Contract #: 04-0120F4
 Cty: SF/ALA Rte: 80 PM: 13.2/13.9
 File #: 69.25B

QUALITY ASSURANCE -- NON-CONFORMANCE REPORT

Report No: NCR-000321

Welding	Concrete	Other	
Welding	Curing	Procedural	Bridge No: 34-0006
Joint fit-up	Coating	Other	Component: North Tower, Lift 1
Procedural	Procedural	Description: Missed MT indication in North Tower, Lift 1

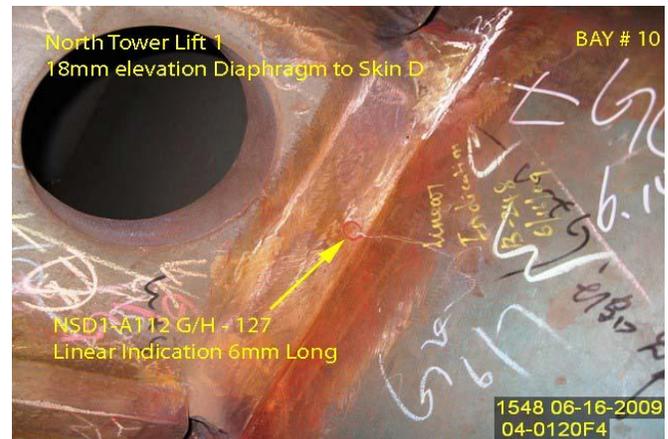
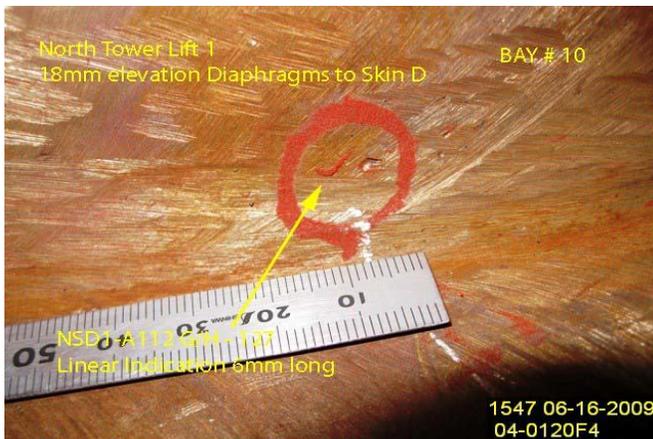
During random verification Magnetic Particle Testing (MT) of North Tower, Lift 1, QA discovered a 6mm long linear indication on 18m Diaphragm to Skin D weld NSD1-A112G/H-127. This weld was previously tested and accepted by ZPMC QC MT Technicians.

Special Provisions Section 8.3 – “Quality Control (QC) shall be the responsibility of the Contractor. As a minimum, the Contractor shall perform inspection and testing of each weld joint prior to welding, during welding, and after welding as specified in this section and to ensure that materials and workmanship conform to the requirements of the contract documents.”

AWS D1.5-2002, Section 6.26.2 – “Welds that are subject to MT in addition to visual inspection shall have no cracks.”

The proposed resolution is acceptable. The welding inspectors have received additional training, and tests have been administered to ZPMC MT technicians to demonstrate their ability to detect MT indications. Also, the weld in question has been accepted by MT as shown in the attached documents. The Department concurs that Non-Conformance ZPMC-0295 is closed.

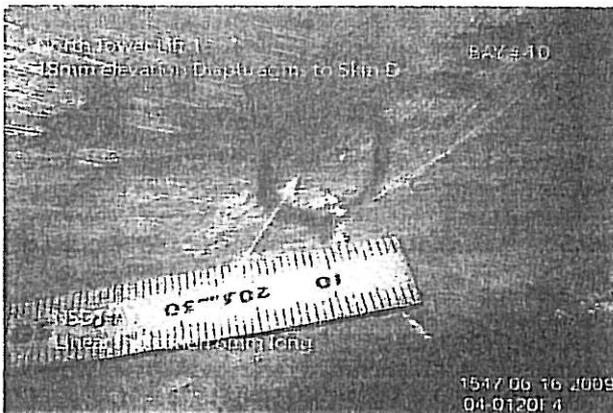
During random verification Magnetic Particle Testing (MT) of North Tower, Lift 1, QA discovered a 6mm long linear indication on 18m Diaphragm to Skin D weld NSD1-A112G/H-127. This weld was previously tested and accepted by ZPMC QC MT Technicians.

The affected weld has been repaired and a NDT report indicating sound welds has been submitted. The weld was verified by QA following the repair.
